**APPLICATION NO:** 20/03392/FUL

**DESCRIPTION:** Convert a redundant farm building into an agriculturally tied dwelling to house a farm worker.

**LOCATION:** Barn North of Village Hall, Langridge Lane, Langridge, Bath

## APPENDIX 2. DISTANCE FROM WHICH THE PROPOSED DEVELOPMENT COULD POTENTIALLY BE SEEN

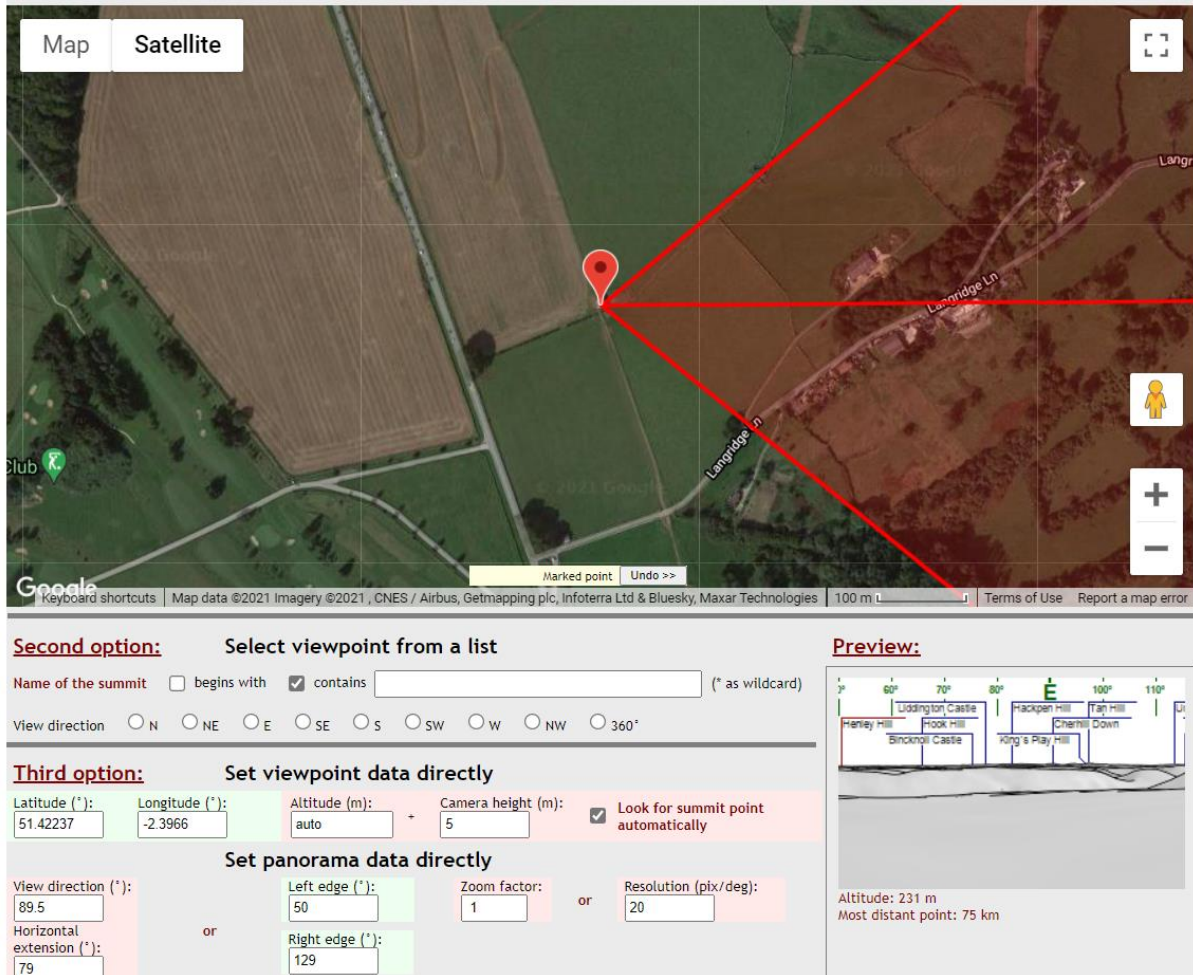
This is demonstrated by the visual panorama software image in Appendix 2, which shows that light emitted from the property could, theoretically, be seen from up to 75km away. More locally, this lighting would appear prominently as an incongruous lit element for users of the A46 and residents of the local hamlets, for example.

The information presented below uses visual panorama software from the Ulrich Deuschle website ([https://udeuschle.de/panoramas/makepanoramas\\_en.htm](https://udeuschle.de/panoramas/makepanoramas_en.htm)). This indicates that light emitted through windows in the east elevation of the building, for example, could, in theory, be seen up to approximately 75km away (i.e. in the North Wessex Downs AONB, well beyond the boundary of the Cotswolds National Landscape).

- the area of glazing on the east elevation should be substantially reduced;
- the design should not include sky lights.
